UNITED STATES PATENT AND TRADEMARK OFFICE

APPLICATION NO.	FILING DATE	FIRST NAMED INVENTOR	ATTORNEY DOCKET NO.	CONFIRMATION NO.
10/616,090	07/08/2003	Douglas M. Baney	10020766-1	9657

Office Action Summary

DETAILED ACTION

Fig. 9

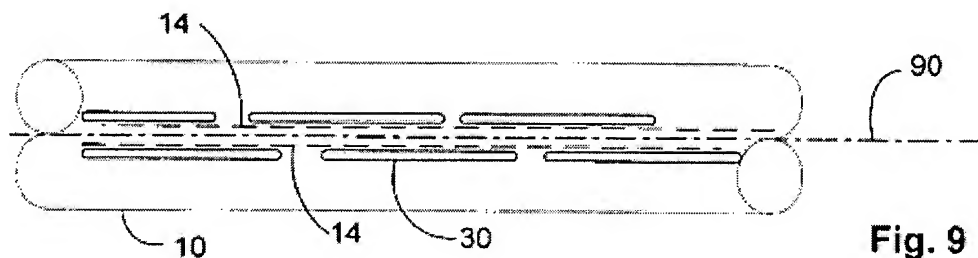
Levenson discloses the method of filling the holey waveguide with the known selective absorption medium through capillary action from the holes in the cladding (Fig. 9 and col. 4, lines 1-6) for the purpose of controlling the refractive index of the waveguide. Furthermore, Levenson teaches that the same filling method in the fluid phase can fill the voids in a holey or photonic crystal fiber (col. 7, lines 49-55).

It would have been obvious at the time the invention was made to a person having ordinary skill in the art to recognize the filling technique through capillary action, as disclosed by Levenson, would be applicable in the manufacturing of the absorption cell of Bjarklev. **The motivation** for employing the filling method as taught by Levenson by immersing the holey waveguide in a gas or liquid and allows the medium to absorb into the holes through capillary action is a cost effective method versus, for example, vacuum impregnation.

Fig. 1

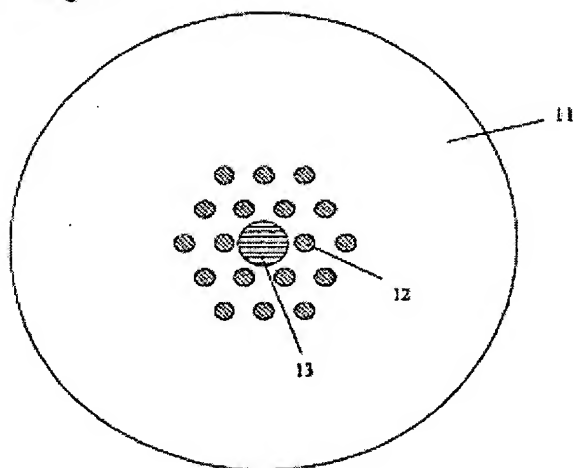
Russell discloses fusion splicing a standard waveguide with a holey waveguide by means of fusion splicing and the conventional adhesive (See col. 3, lines 33-50) for the purpose of coupling a standard waveguide with a holey waveguide and maintains the fundamental mode.

It would have been obvious at the time the invention was made to a person having ordinary skill in the art to recognize the fusion splicing technique or using an adhesive as disclosed by Russell would be applicable in the manufacturing of the absorption cell.. **The**

motivation for employing fusion splicing or adhesive as the coupling means in the absorption cell is to improve coupling efficiency at the coupled points.
